保育舊城中環 珍惜特色唐樓

URA's scheme

Government Hill & Bishop Hill

Space for public use within the Former Central Government Offices site

Figure 17 View from Caine Road

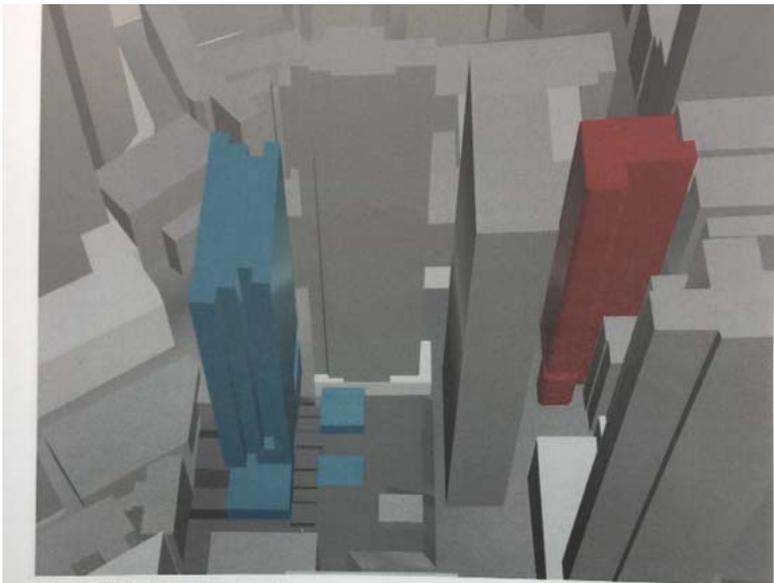
關注組促請區議會、發展局 及城規會制止市建局破壞舊 城的暴行

特色唐樓可以好好保育 成為舊城中環的亮點
